Re: Application by Kanaris Demetre Lazos for a Her	Application by Kanaris Demetre Lazos for a Heritage Alteration Permit at	
From: Wayne Craig Director, Development	File:	HA 18 - 804880
To: Planning Committee	Date:	April 4, 2018

12111 3rd Avenue (Steveston Hotel)

HA 18-804880

ATTACHMENT 5

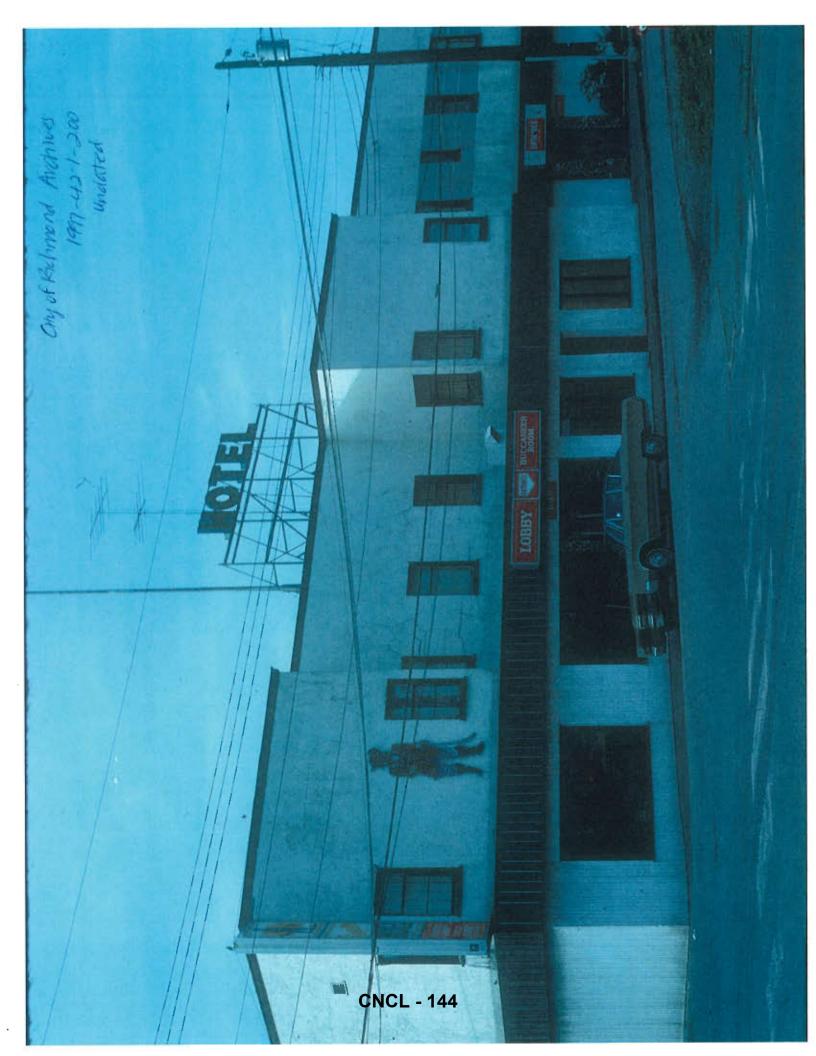
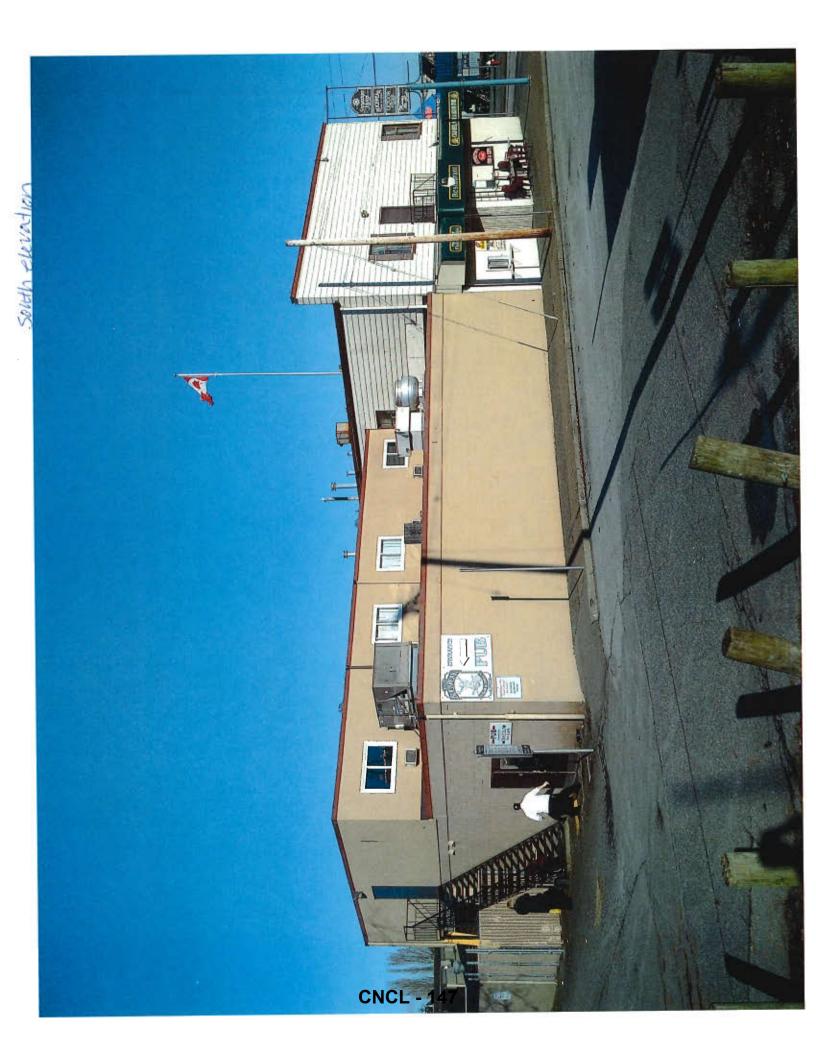
All the existing upper-level windows are single-pane aluminum windows, except for the eight small sliding windows in the south and north facades, which are white vinyl-framed windows. The existing aluminum windows are fixed windows and are not operable. The attached photos (Attachment 5) show the existing windows.

The proposal is to replace all 41 upper-level windows with black vinyl-framed, double-pane windows for energy efficiency and noise mitigation within the hotel. All the larger windows and the eight small windows in the south and north facades will be clear glass, and the eight bathroom windows in the east and west façades (i.e., front and rear façades) will be frosted glass to add privacy.

All the proposed windows are awning windows (i.e., hinged at the top) except for the small windows in the north and south facades, which will be sliding windows. The width of the existing aluminum window frame is ³/₄ inches and the width of the proposed vinyl frame is ¹/₂ inches to match the slim look of the existing aluminum frames.

The existing wooden brick moulding (note: brick mould is a term that refers to a decorative trim that fills the gap between the window frame and masonry opening) and wooden window sills, which provide a traditional look, will be retained and repainted to match the proposed black vinyl frames. The new windows will be inserted into existing openings from inside without disrupting the exterior cladding.

The applicant has also proposed to remove the decorative shutters, which are not operable, on the upper floor. The shutters are not original, or a character-defining element. The existing shutters were installed over the siding, and the siding will remain unchanged after the removal of the shutters.

Members discussed the proposed window patterns and noted that the proposed pattern with the T-shaped divider is supportable as it would help achieve the historic look.

That the Richmond Heritage Commission support the proposed windows and removal of existing shutters as presented.
